CHAHAL SEMI TRUCK/TRAILER REPAIR FACILITY

6100 SCHOONER DRIVE
VAN BUREN TOWNSHIP, WAYNE COUNTY, MICHIGAN

To: OHM
County review R22-0560

OHM review #2 response letter:

SCALE: 1"=40' HORIZONTAL
1"= 4' VERTICAL

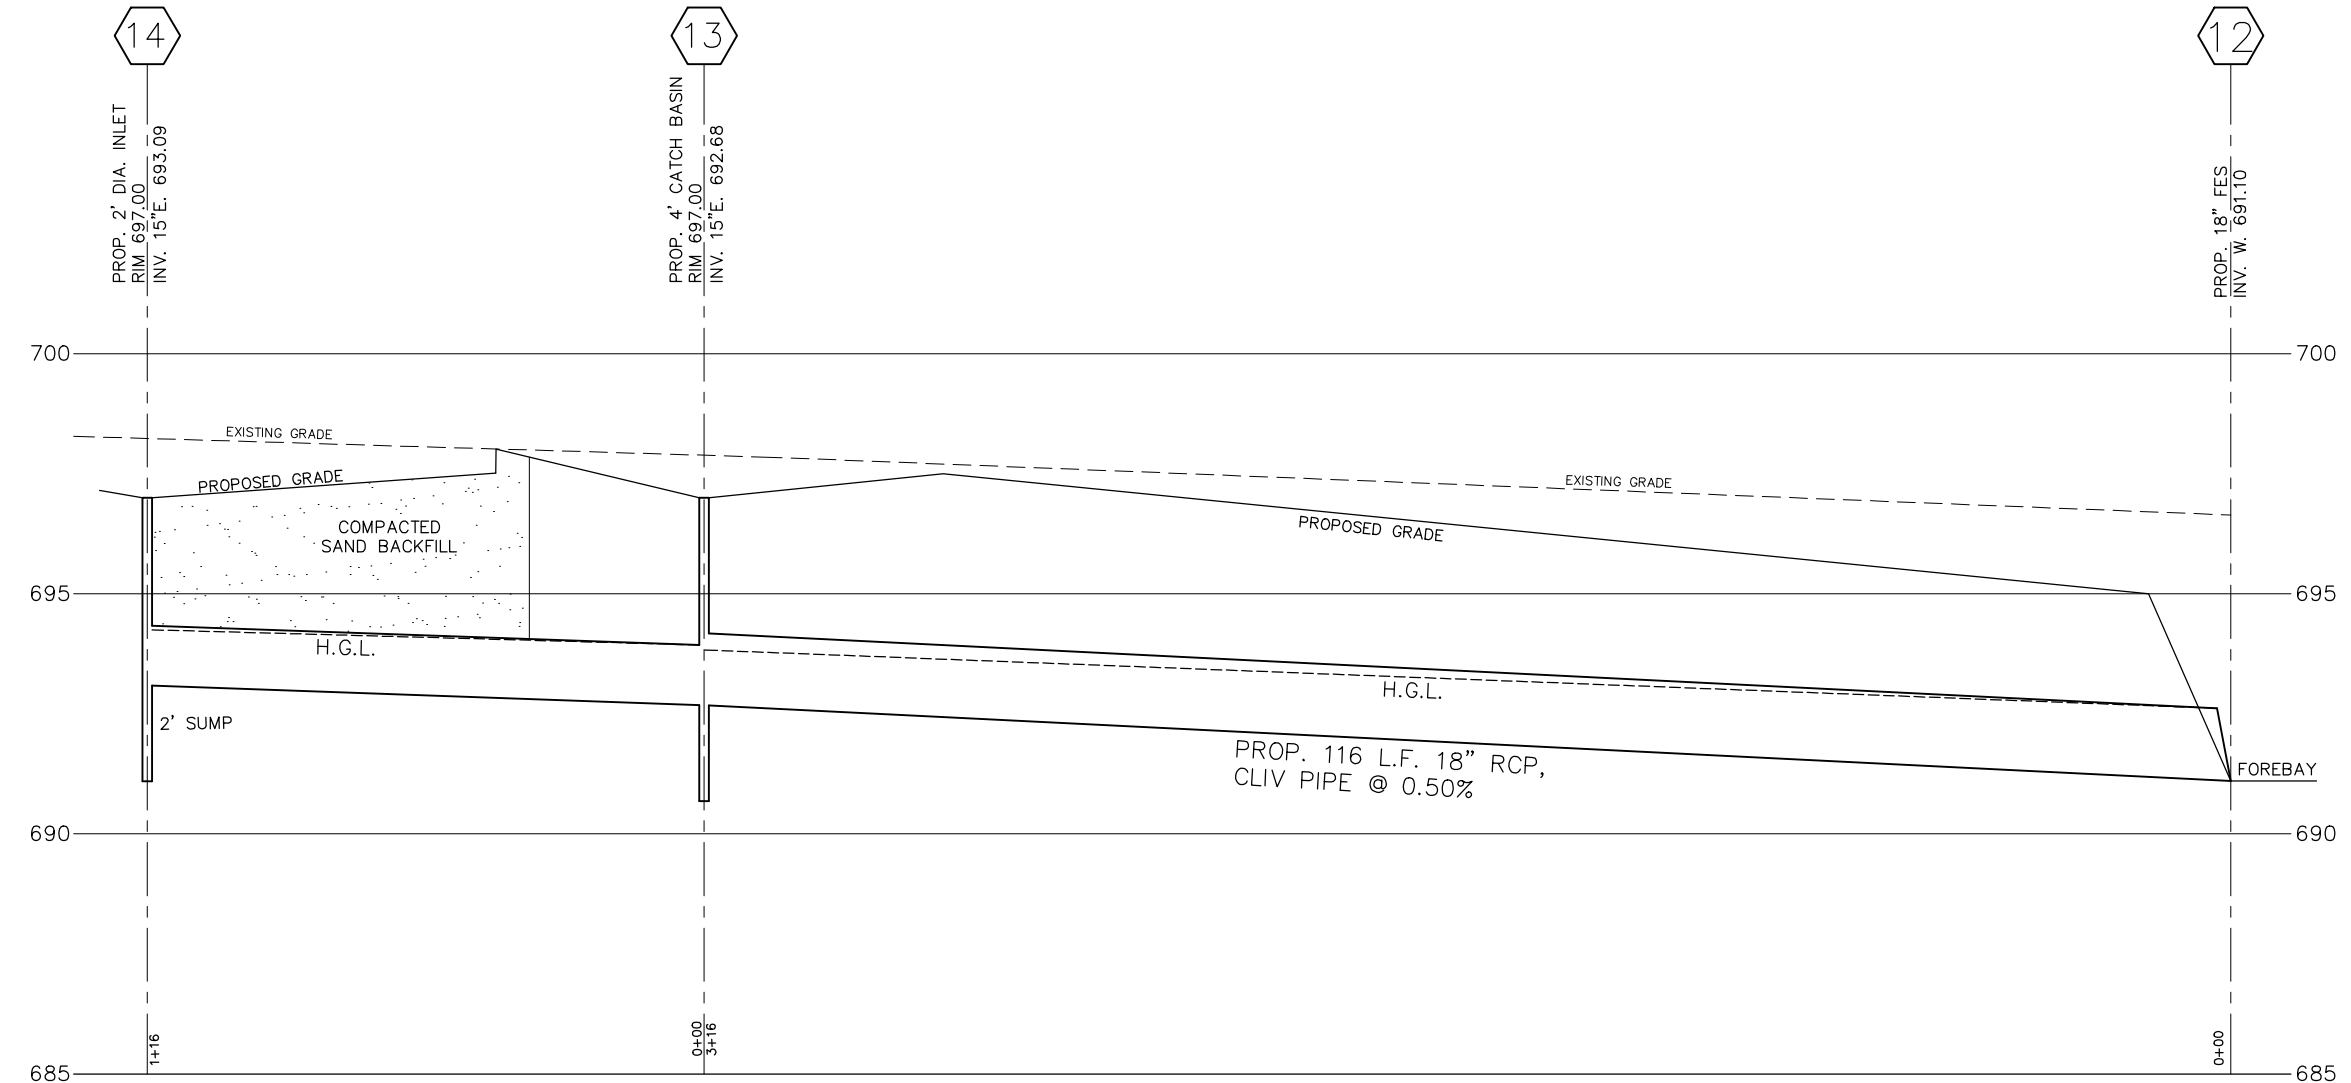
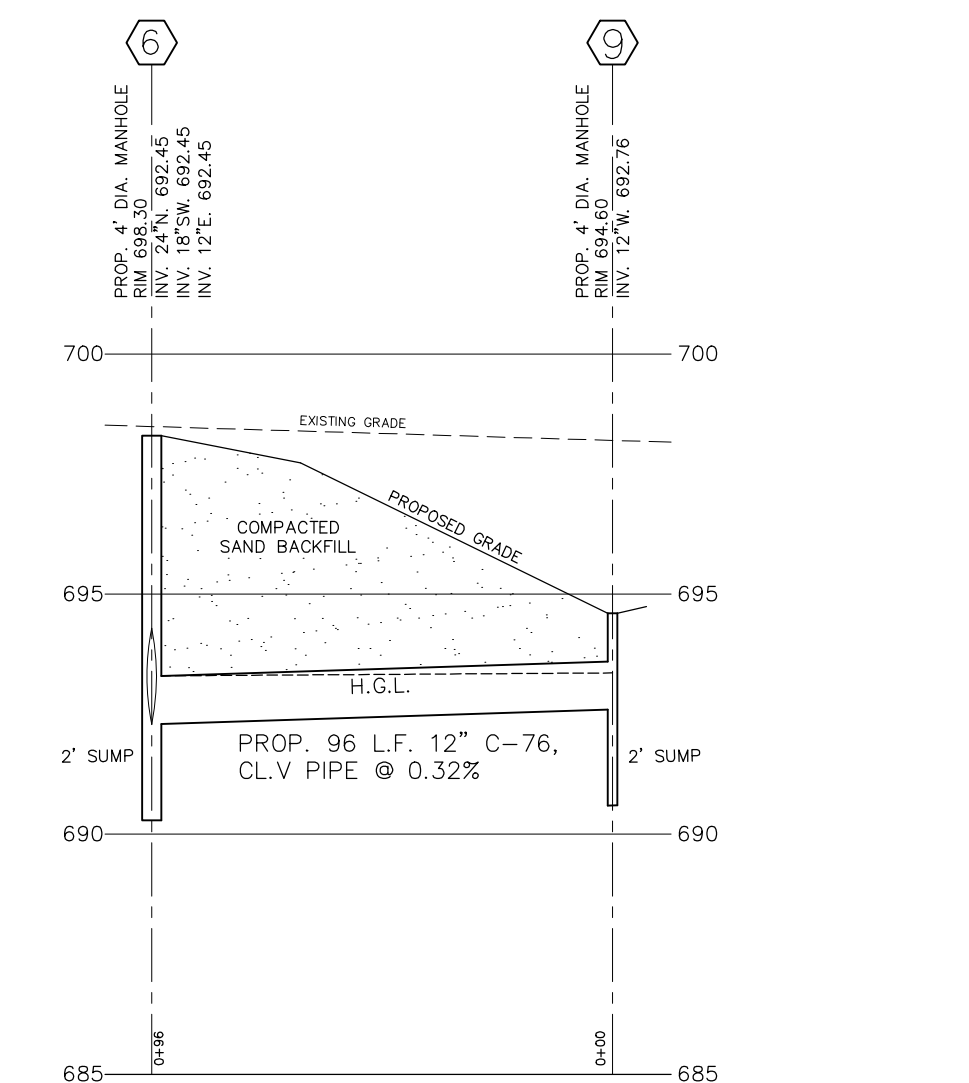
3. Soils information shown on sheet #7 along with a statement of our findings.
4. "D" is not a manhole; it is a flared end section as revised on profiles. Invert elevations have been added to catch basins along the southerly property line. All obtainable existing storm sewer information is shown on the plans.

9. Storm sewer management calculations have been revised.
10. HGL calculations have been added to storm design table.
11. Storm sewer run D-E has been revised. Storm sewer run B-A has also been revised.

DETAIL FOREBAY OUTLET STRUCTURE "E"

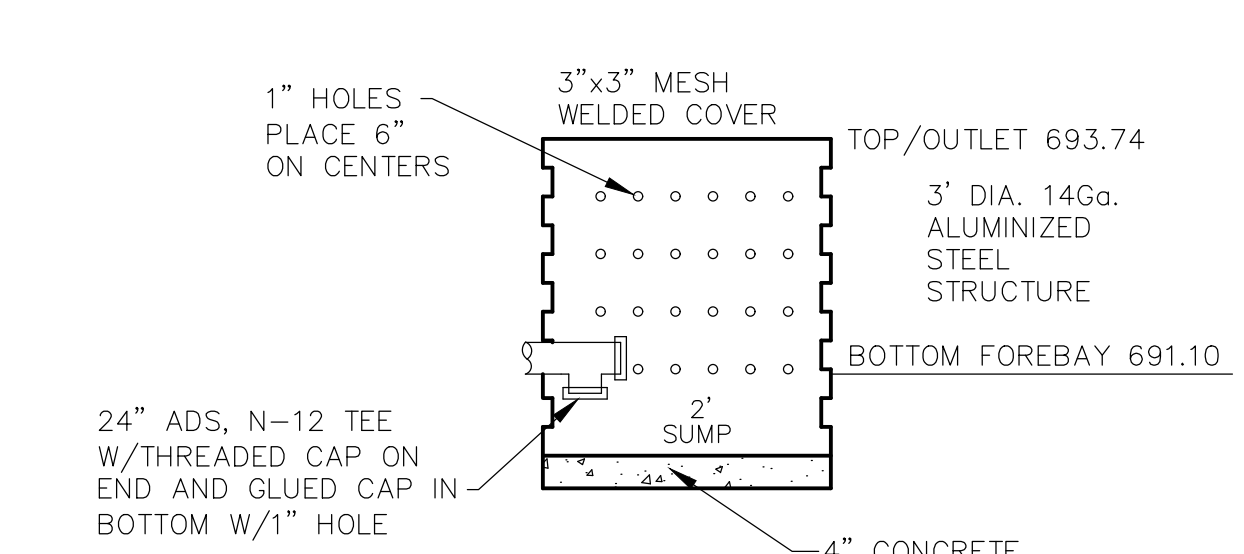
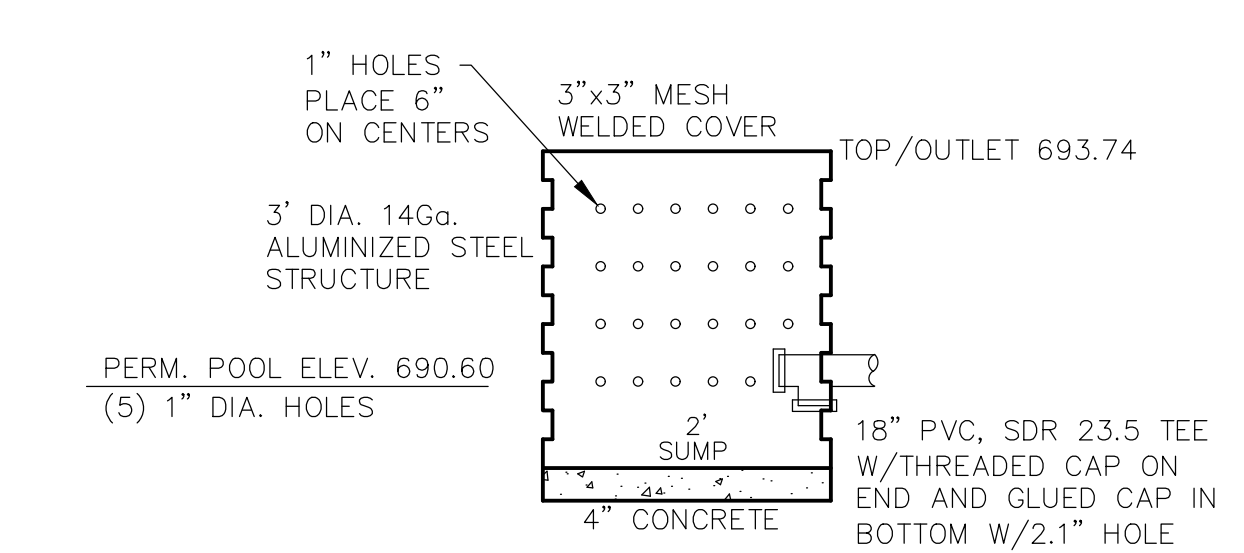
12. Permanent pool elevation is labeled on sheets #3 and #4.
13. "D" is not a manhole; it is a flared end section as revised on profiles.
14. Per Wayne County Storm Management requirements, as stated on page 41 under section 6.3.4 (Buffer Strip) it states "a site that is less than 5 acres, a buffer strip of 15 feet wide must be established. A copy of this page is included in this response letter.
